ADDENDUM No. 3
Request for Competitive Sealed Proposals (CSP)
19CSP067 HVAC and Electrical Improvements at Hill
Elementary School

ADDENDUM NUMBER 3

Project: **HVAC and Electrical Upgrades at
Hill Elementary School
Austin Independent School District
PROJECT NO. 19CSP067 (19-0021-HILL)**

SHEET NO.
A102

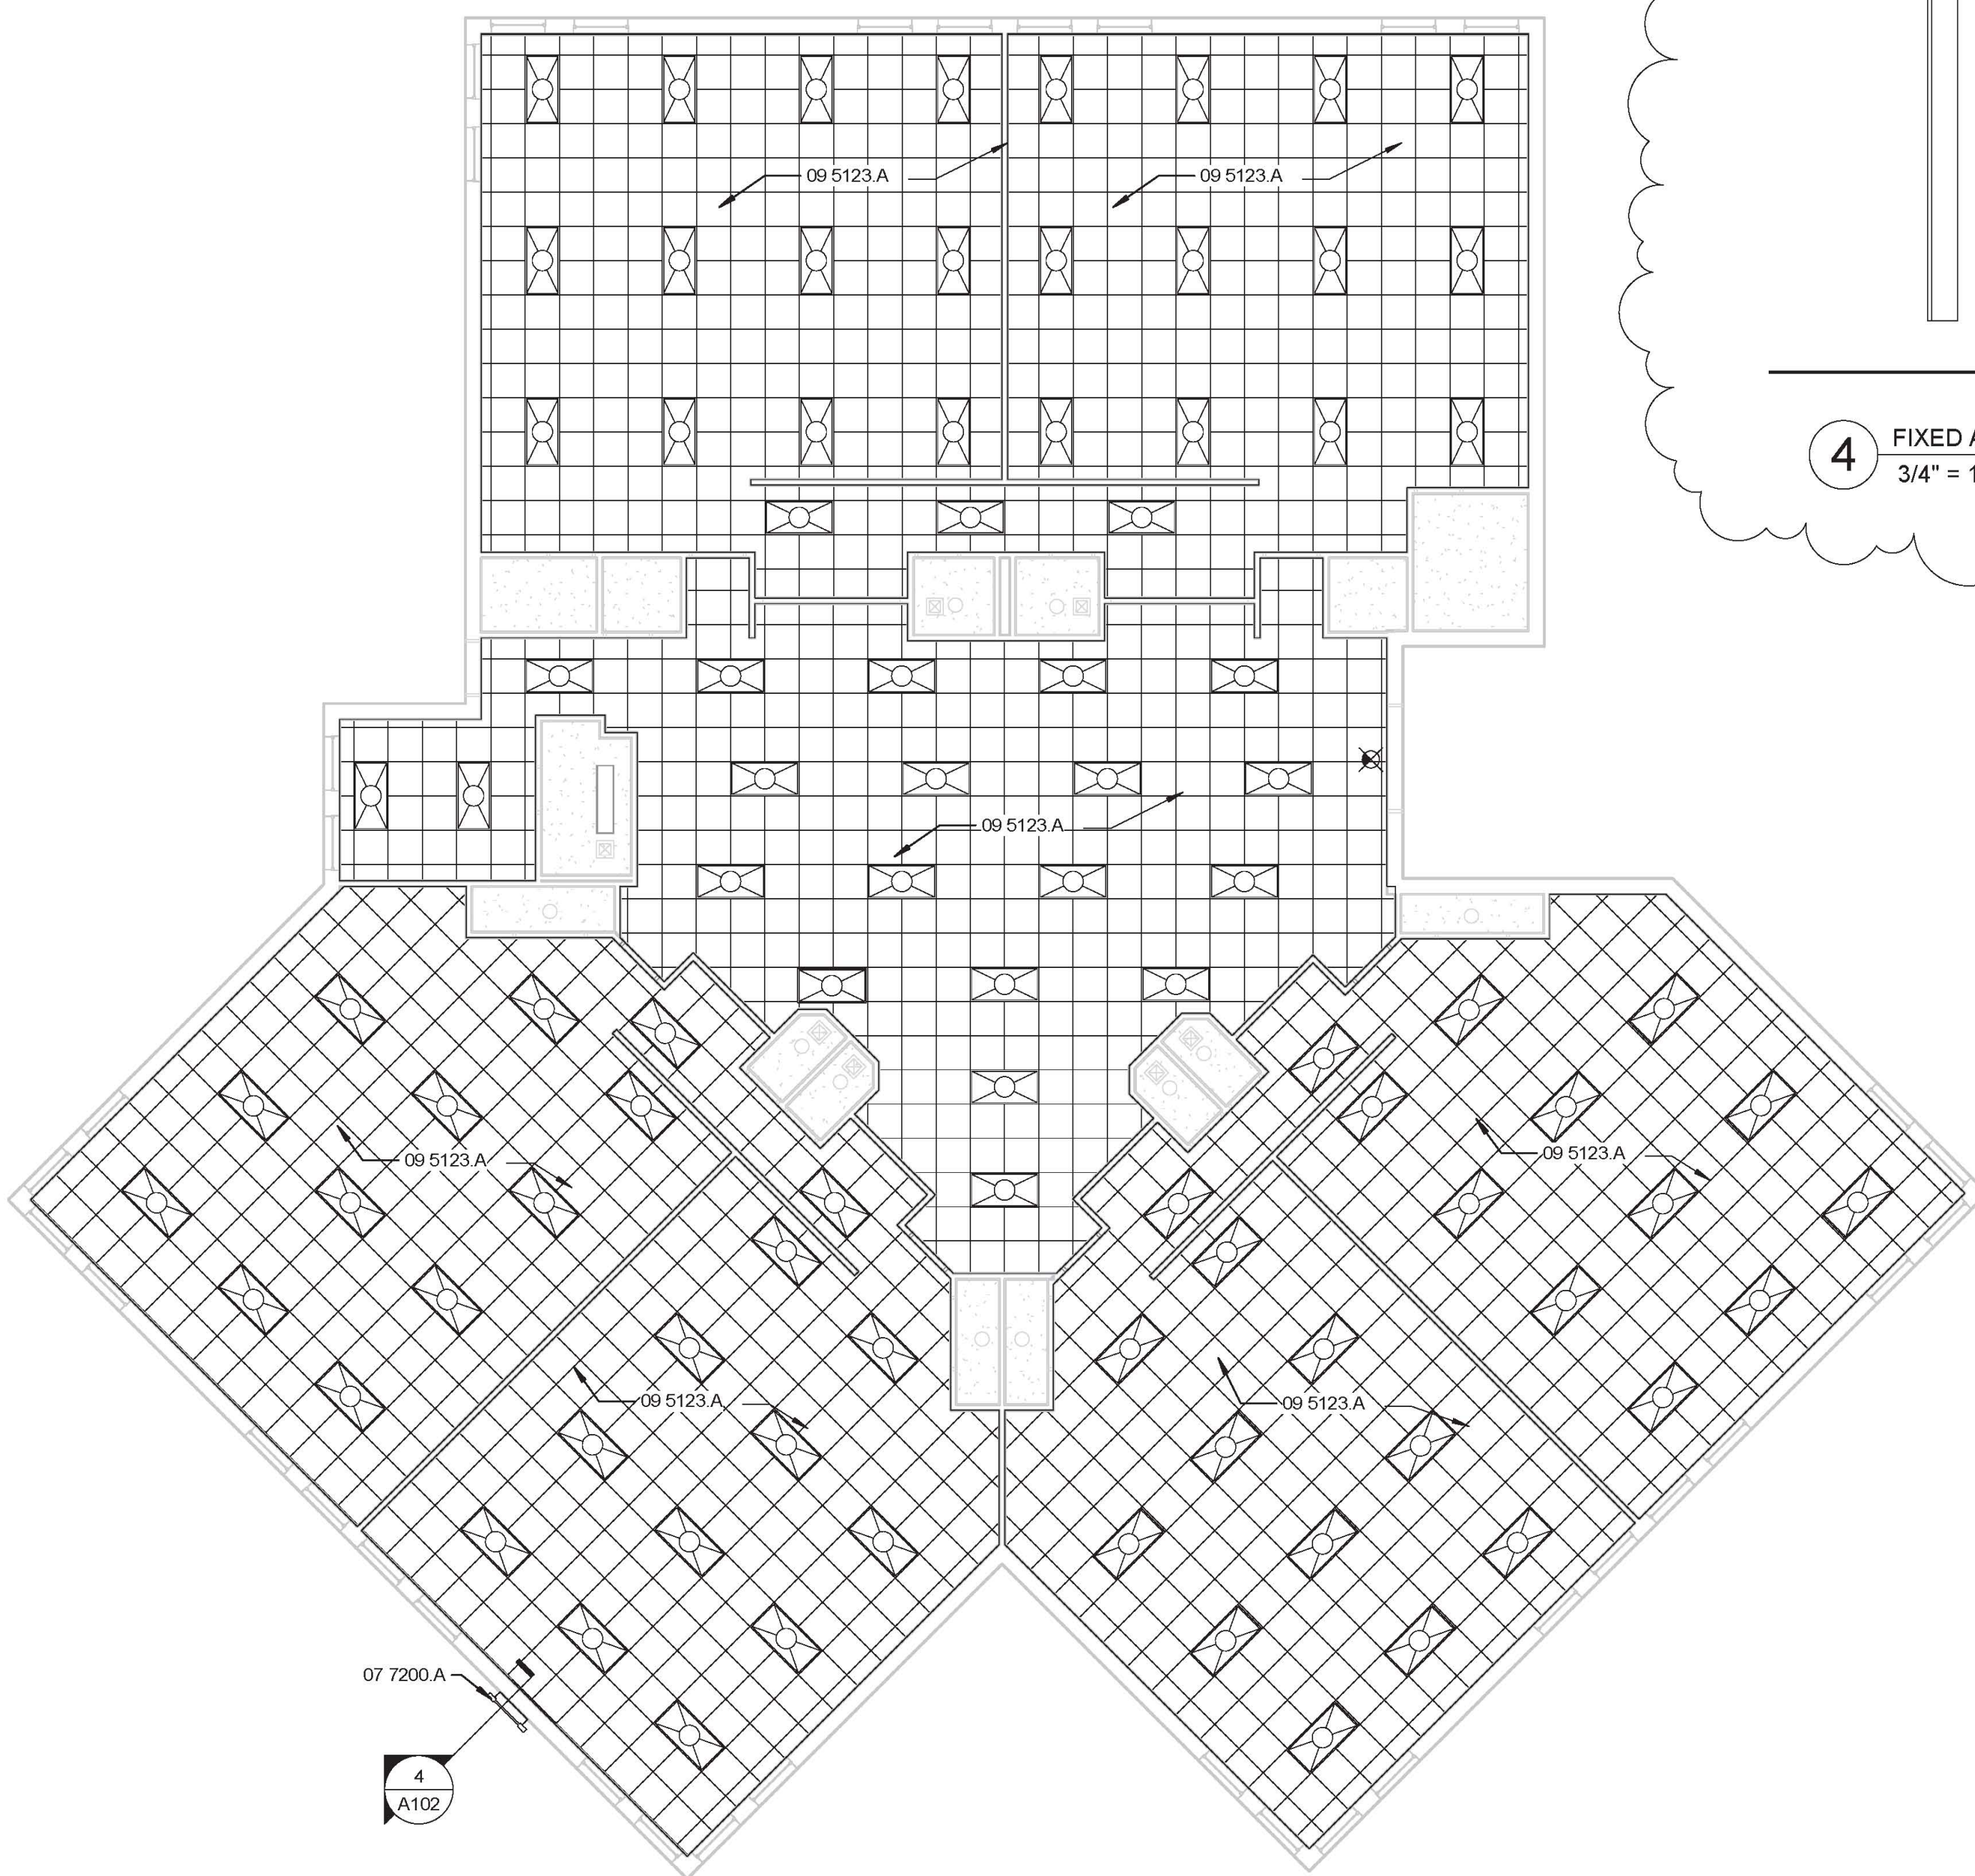
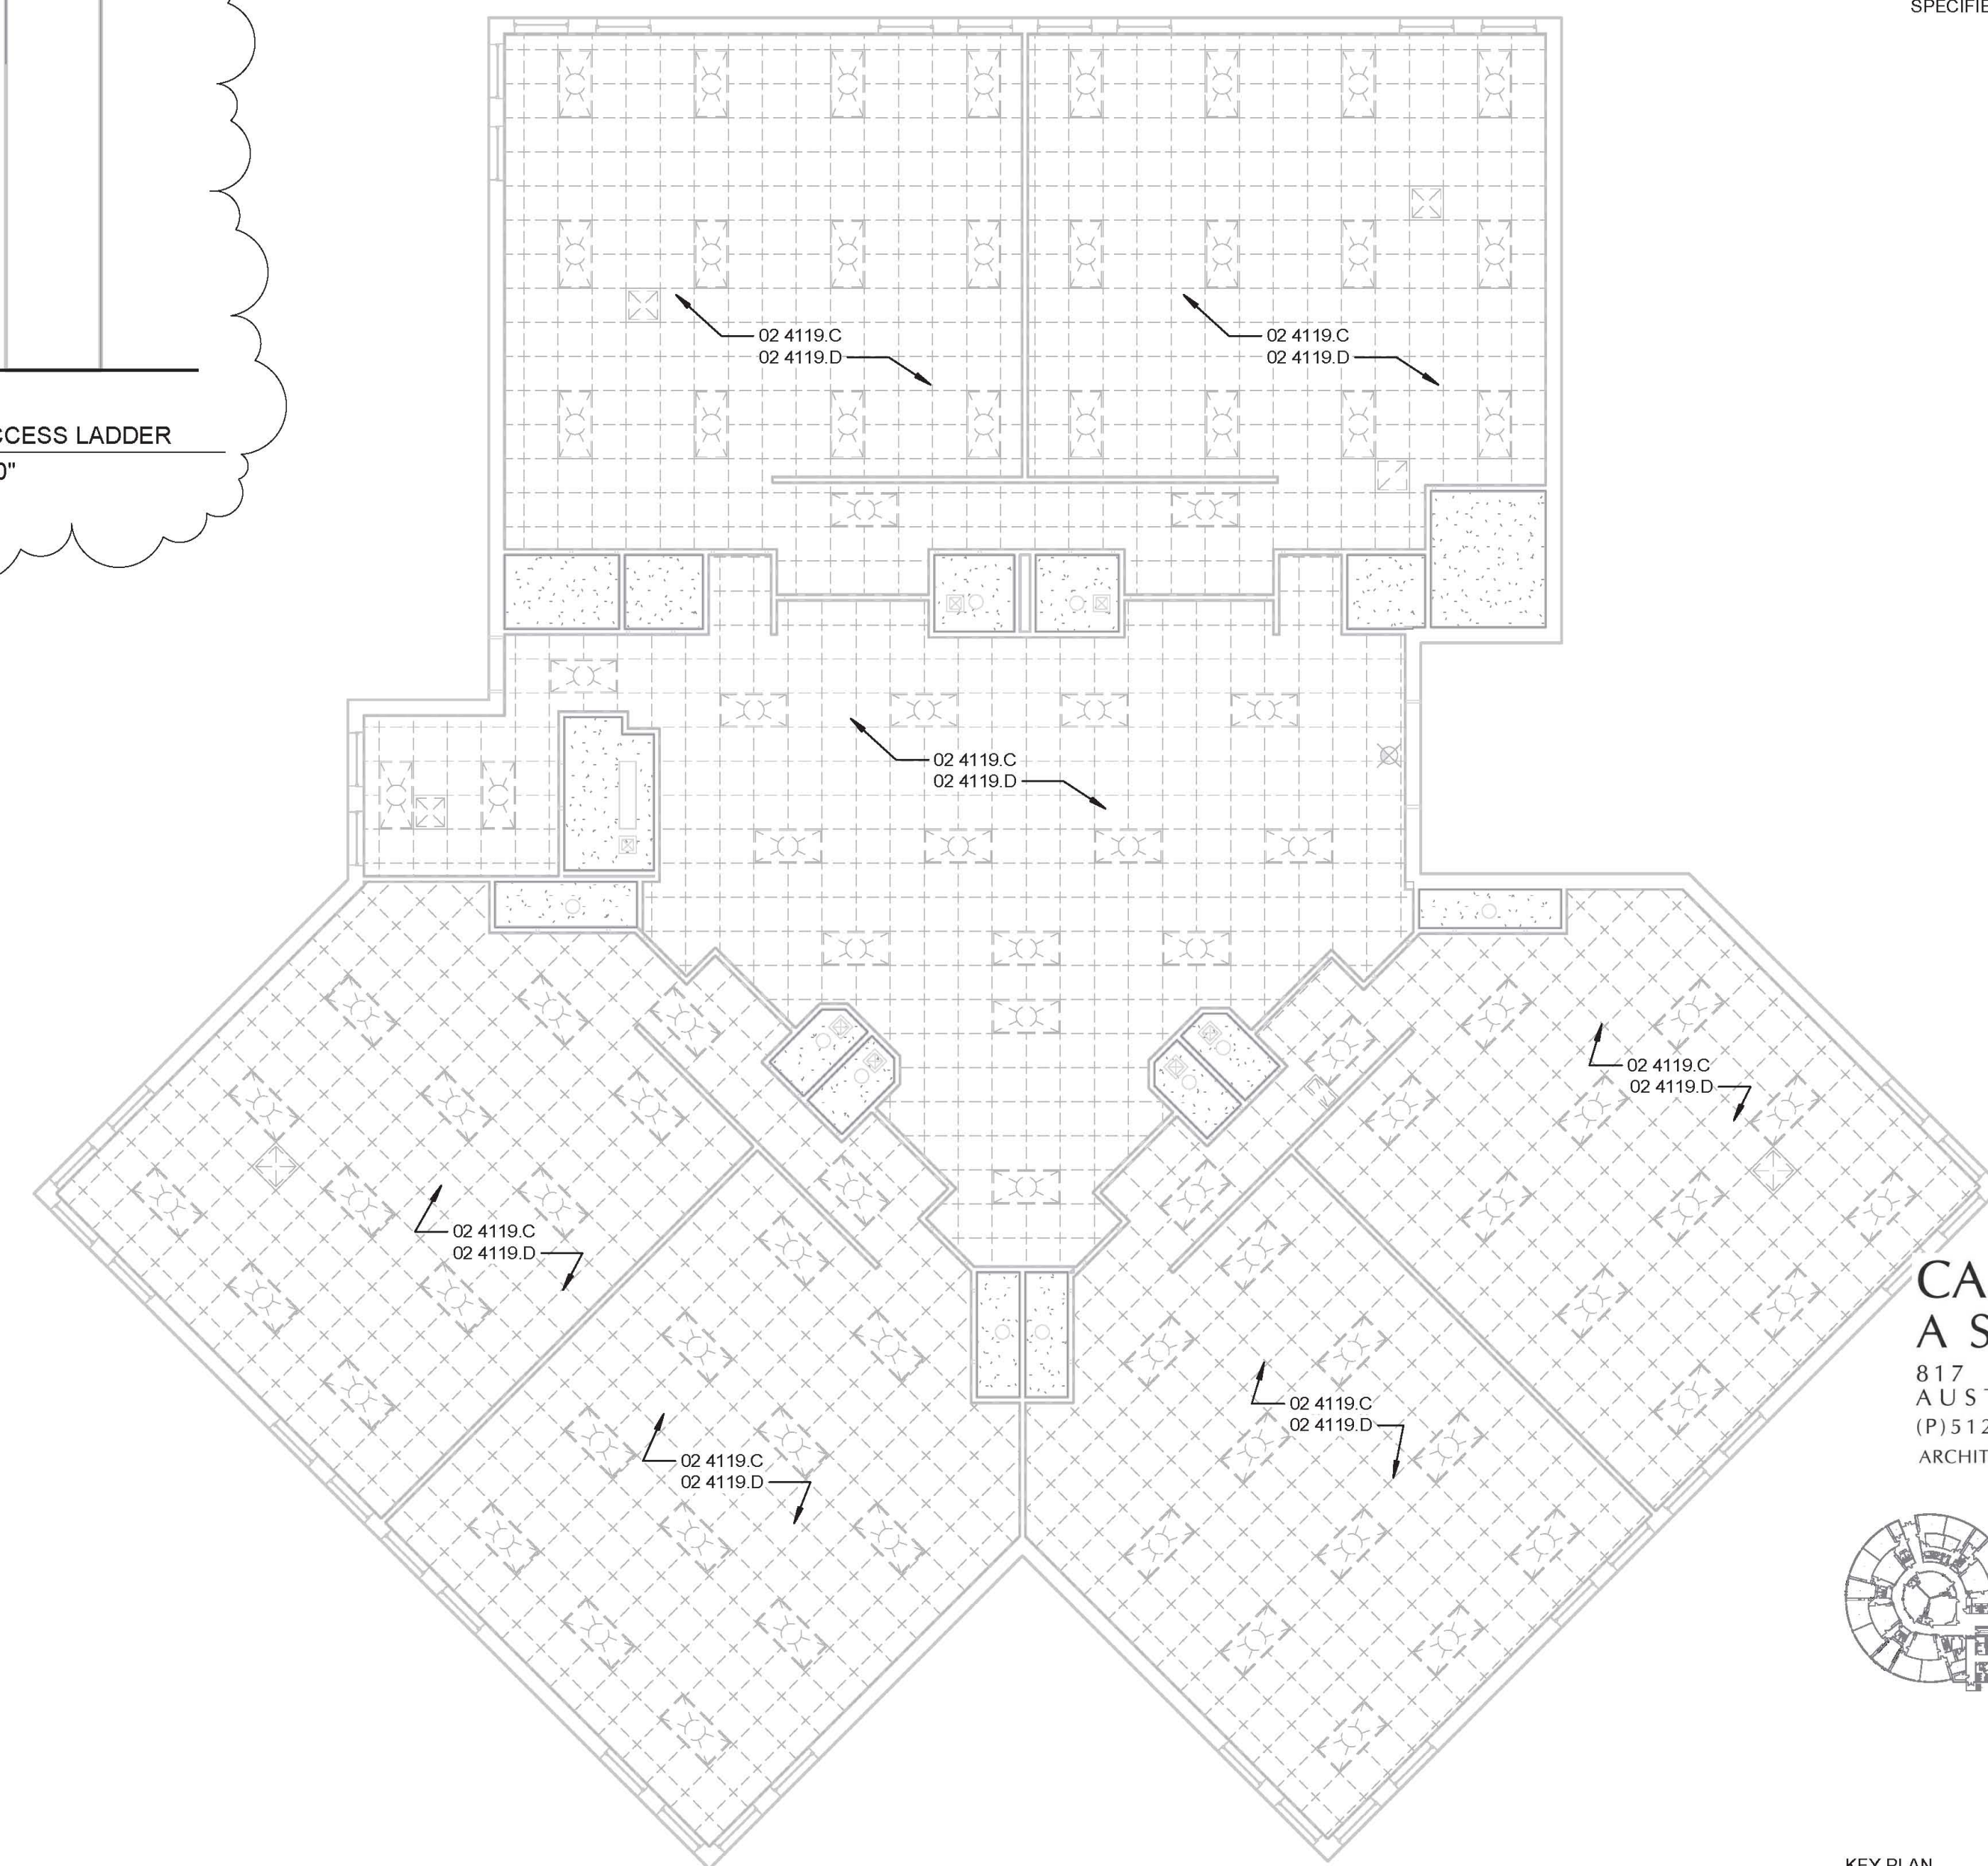
Sheet A102 – Classroom B Reflected Ceiling Plan – Demo and New

- a. Revise roof access ladder attachment locations to building.
